Addendum No. 05

SUBJECT: OR22: Center St Bridge (Phase 1) Project
Willamina-Salem Highway
Marion & Polk Counties
Grading, Drainage, Structures, Paving, Signing, Illumination, And Roadside
Development
(Bids Closing October 8, 2026)

The following changes are made to the Project Special Provisions:

The following changes are made to the Project Plans:

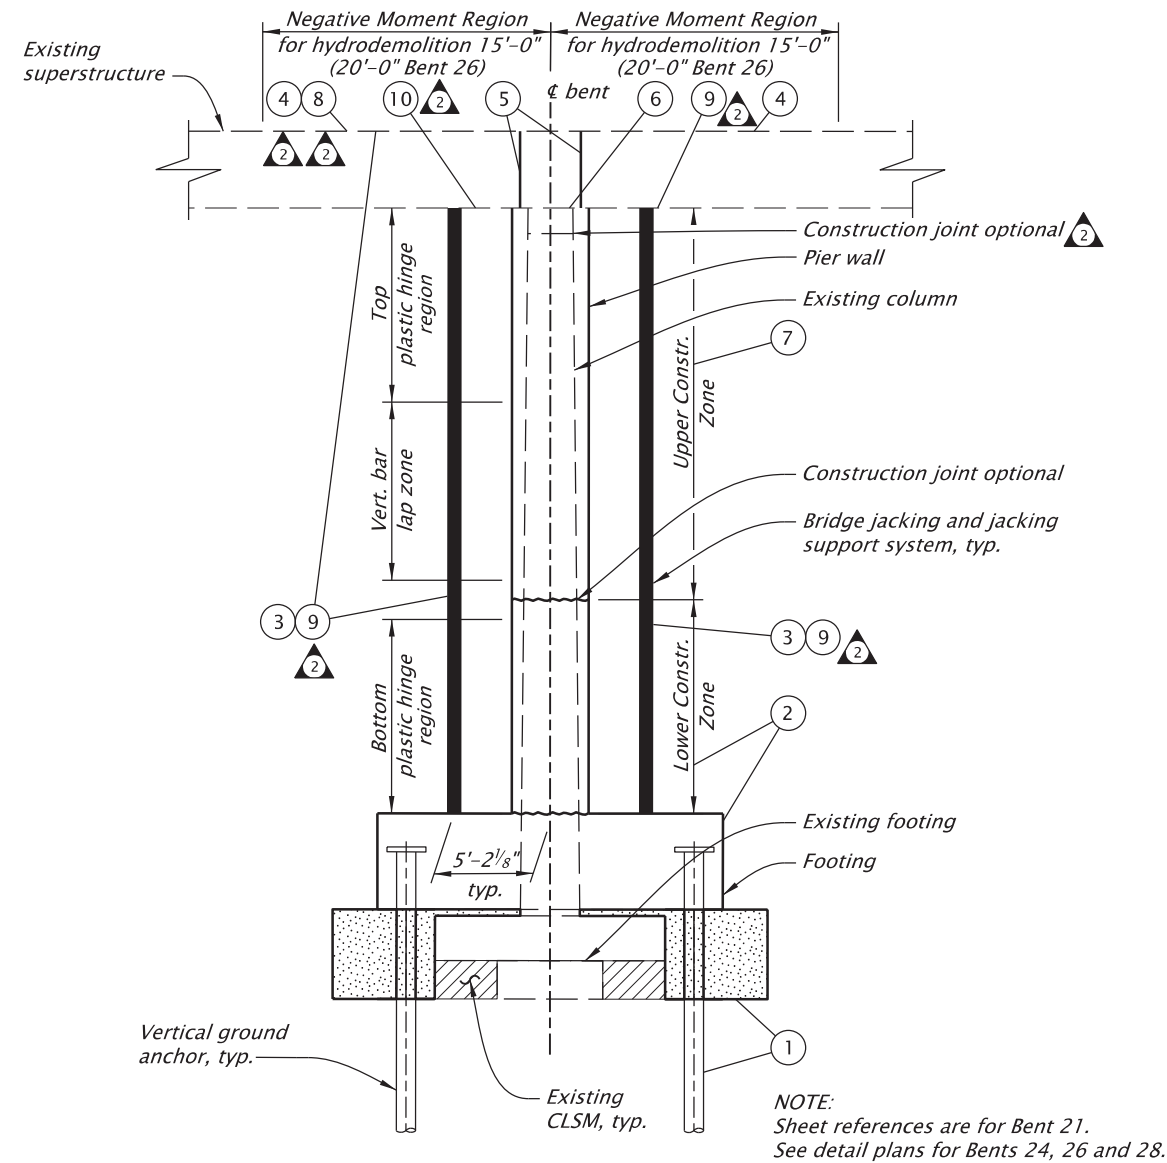
2. Subsection 00760.10 Unit Pavers - The paragraph that begins with the words "Furnish Eco-Priora permeable" is replaced with the following:

Furnish Eco-Priora permeable pavers or Holland Permeare by Western Interlock meeting the following requirements:
